ONE 90 (PREVIOUSLY WATERS TECHNOLOGY PARK )  
PA 18-013 MODIFICATION SUBMITTAL :  
ISSUE DATE: 10-13-20

PA MODIFICATION - INTENT AND DESCRIPTION:  
To review and approve architectural building related design modifications made during plan check for code compliance and constructibility.

PA MODIFICATION COBALT- BLOCKS REVISIONS SUMMARY

PA MODIFICATION - INDIGO ROWS REVISIONS SUMMARY

GROUND LEVEL PLAN

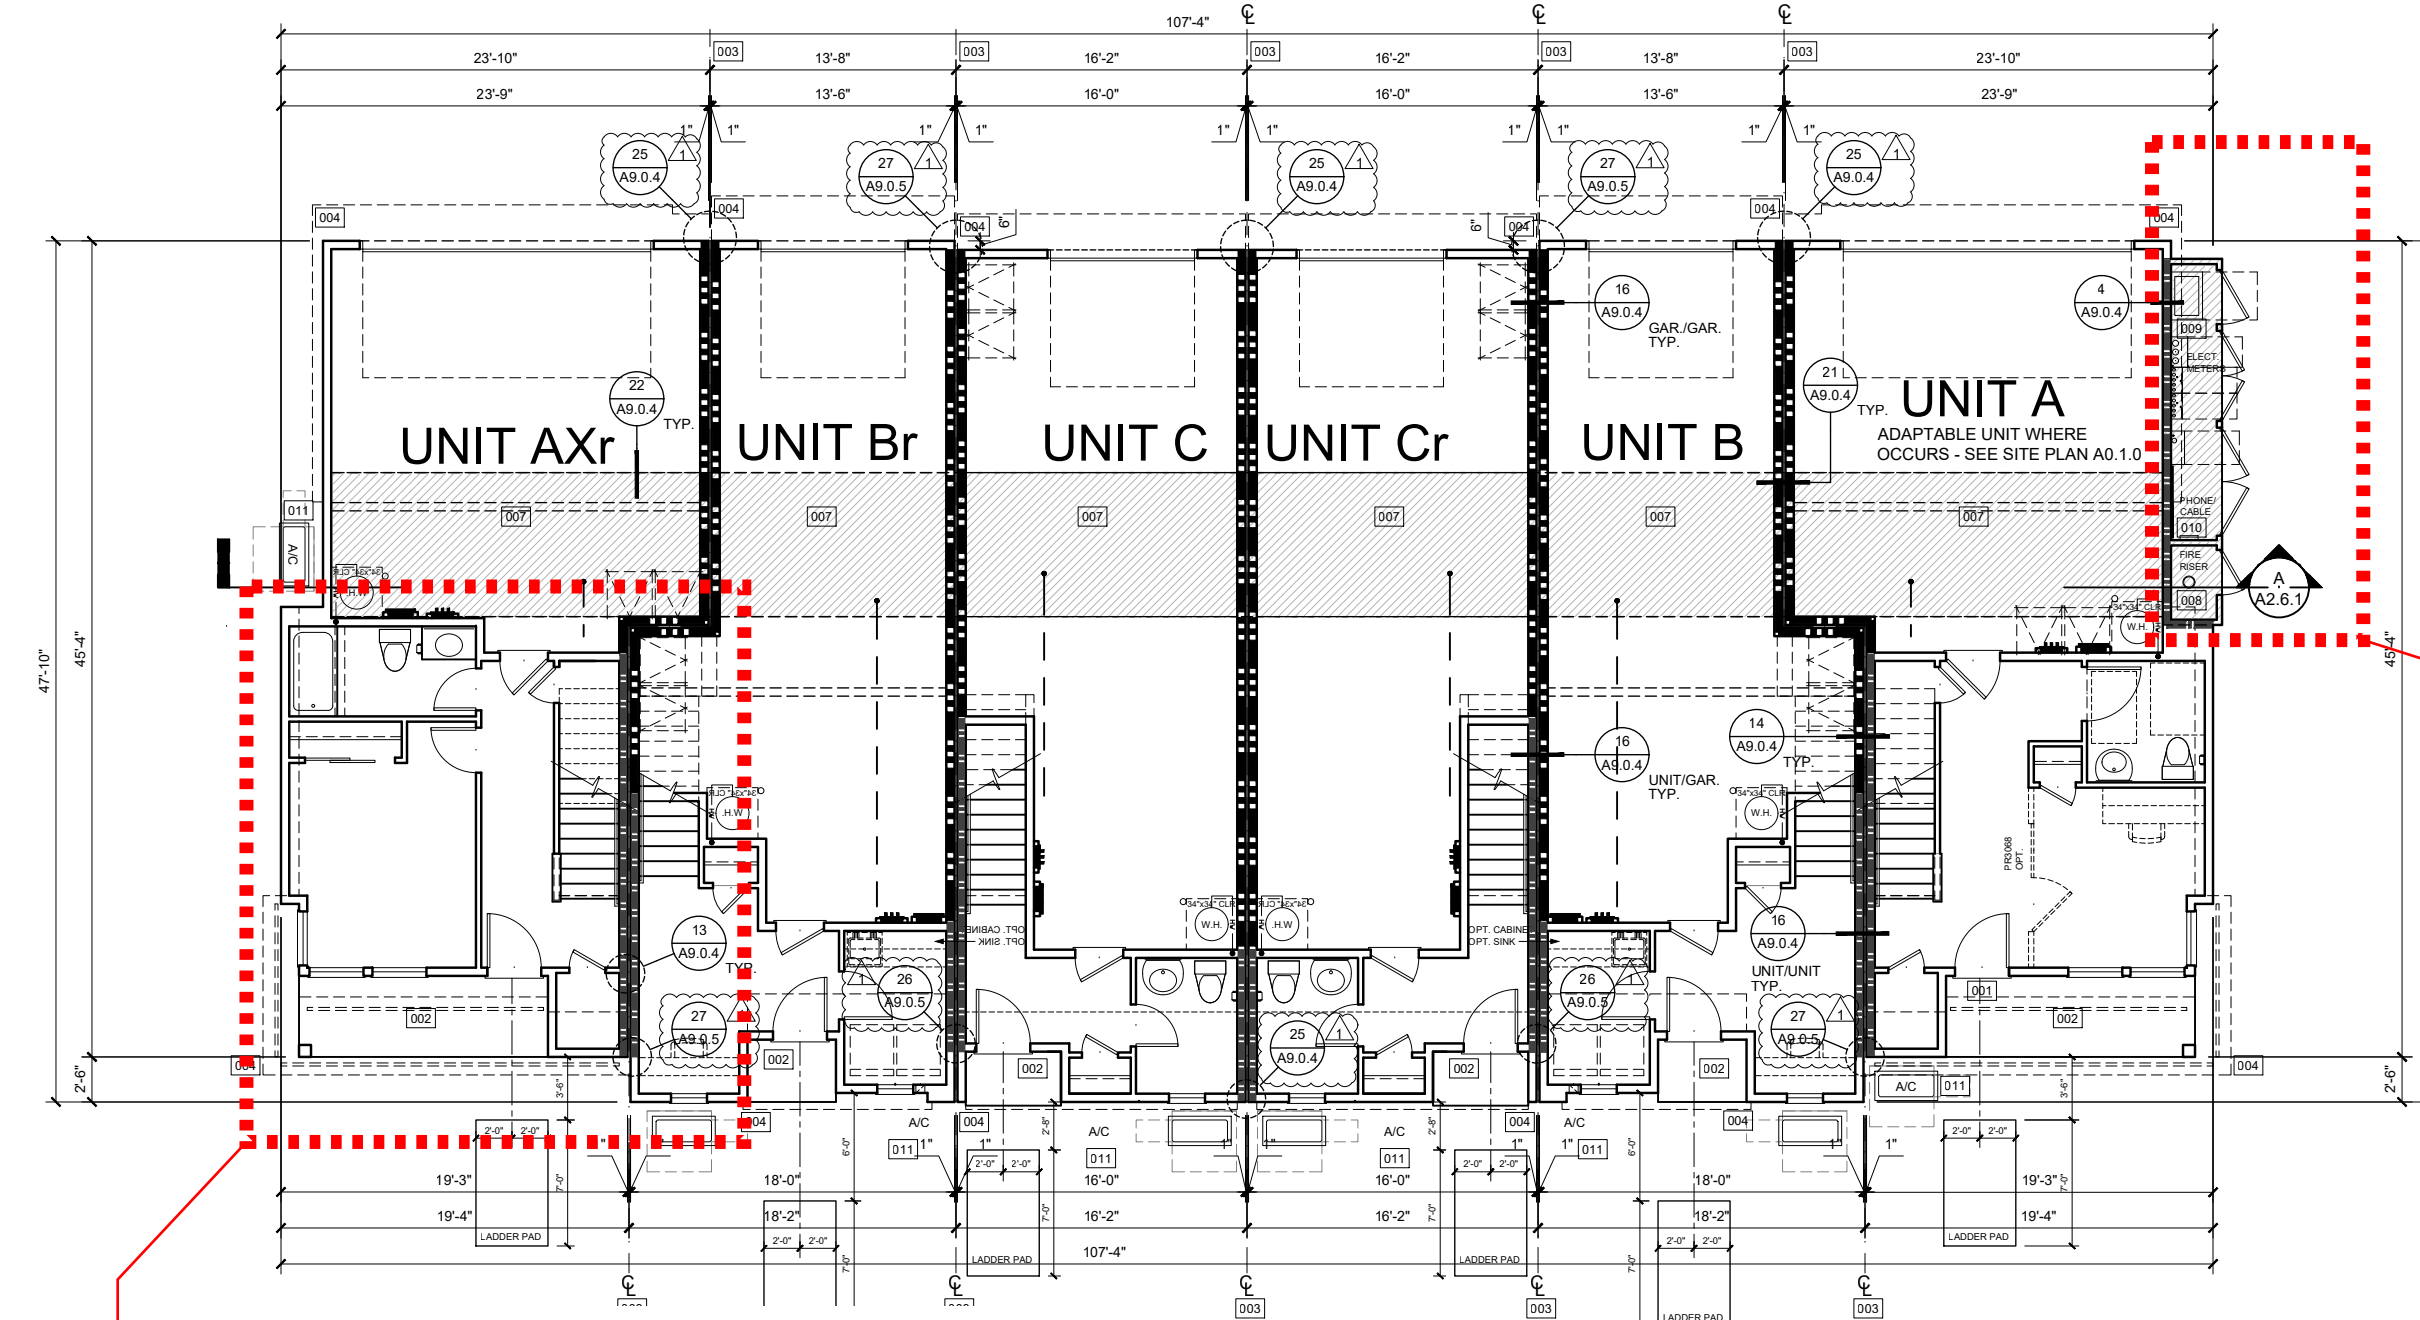
1. Added fire and electrical utility closets
2. Unit AX is revised to accommodate Bedroom 4 and Bath 3 in 5 plex and all 6 plex buildings per PA 18-013 vignette for TH 10

Please note that PA 18-013 plans did not include dimension and the second floor dimensions were measured to interior of the walls and did not include any dimensions to exterior pop out walls.
